RECEIPT DATE: 7/25/2024 **ONSITE SEWAGE DISPOSAL SYSTEM** P 586764

APPROVAL DATE: 9/17/2024 **PERMIT: REPAIR** A Repair

PROPERTY ADDRESS: 12210 Hall Shop Road

# Septic Design Repair Plan

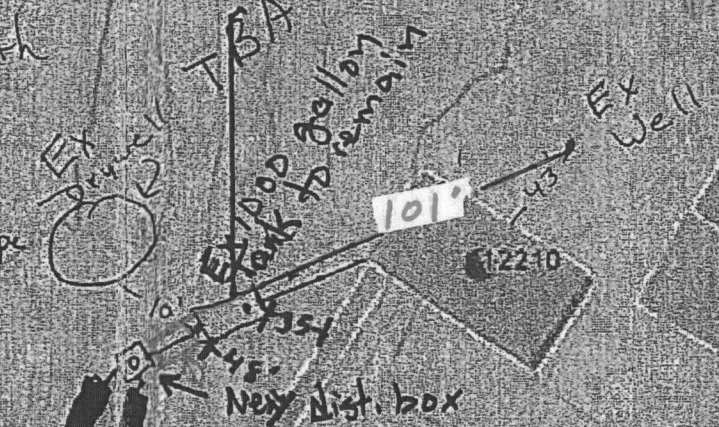
1. Need to add distances from proposed system to property lines
2. Add note for "new dist. box"
3. Add note for "proposed trenches"
4. Add note for "existing \_\_\_\_gallon septic tank to remain"
5. Add a title to the plan (i.e. septic repair design plan)
6. For all future plans, on the section that says "Installer Information", please add "Plan Preparer" or "Plan submitted by.." then company name.
